Brisbane Road Carpark Redevelopment

independent landscape assessment report

Prepared for Ethos Urban /
Sunshine Coast Council

Attachment 6 Landscape Architecture Assessment

suggested enlargement area

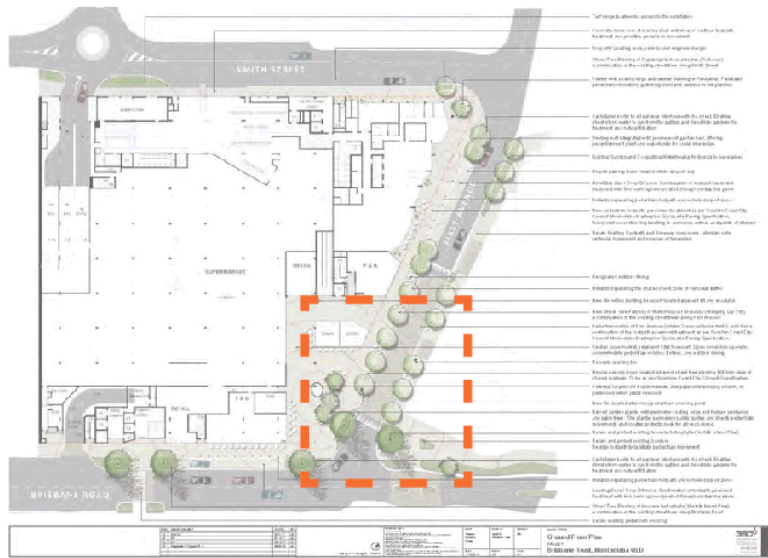
The design illustrates a site layout (ground level) that shows the proposed shared zone and pedestrian areas, including all elements noted above. However, a finer level of detail (as an enlargement plan) should be provided to show a more detailed level of design to illustrate 'outstanding and highly articulated landmark' design . At present the level of detail (1:400 at A3) does not provide sufficient information to portray these qualities.

An enlargement plan at eg 1:200 or better for the suggested area below would show more detail to describe the level of design articulation.

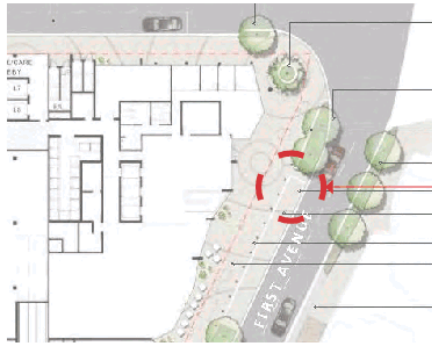
The scheme is compliant, excepting P032 (a) in relation to placement of bicycle racks in the drop off bay of First Avenue. Refer to recommendations in this report.

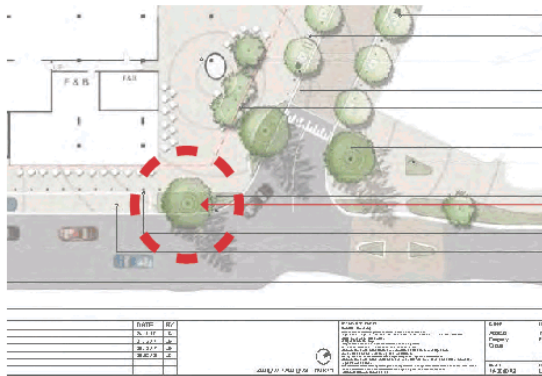
2. Bicycle hoops currently located within drop off bay, in potential conflict with vehicular traffic.

Recommendation:
Relocate into pedestrian zone.

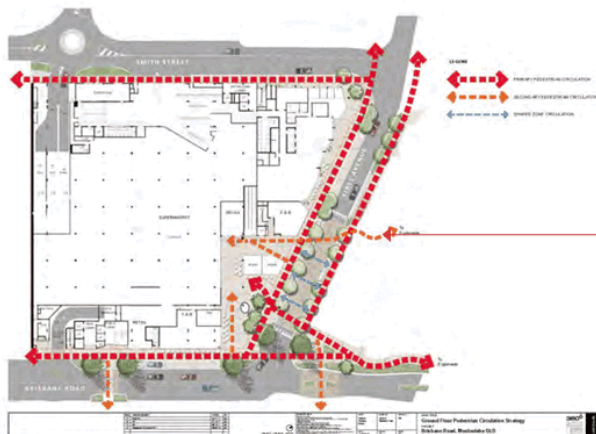
3. Araucaria heterophylla may infringe traffic sightlines.

Recommendation:
Ensure compliance and relocate if necessary.

More detailed information

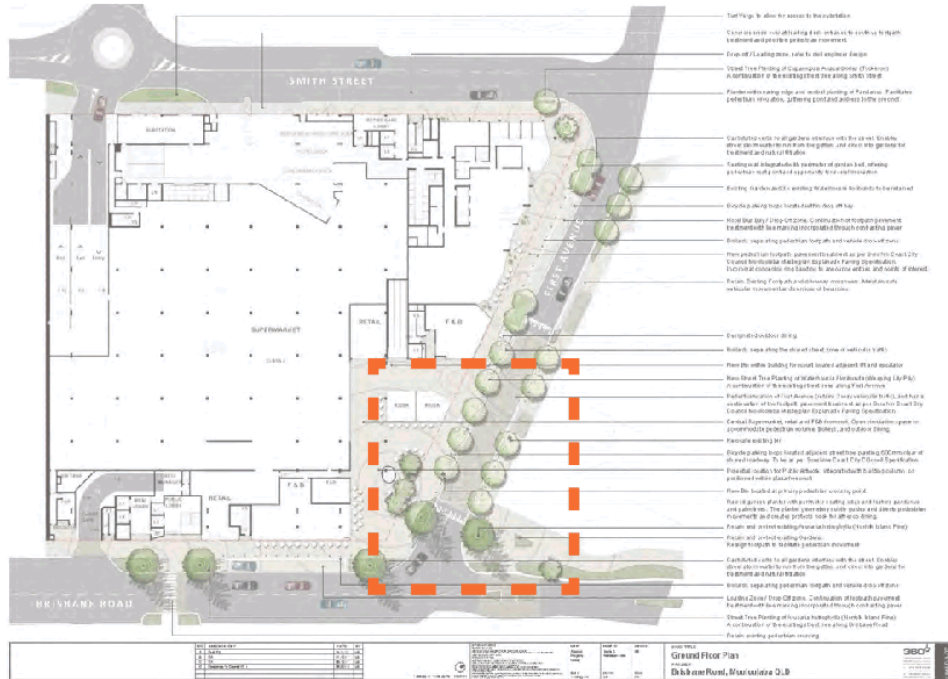
To ensure that this design adequately fulfills the requirement of a 'landmark, outstanding streetscape and landscape design which is highly articulated', the applicant is encouraged to provide a more detailed enlargement plan of the area indicated below, to be provided as part of detailed design within a subsequent Operational Works landscape application.
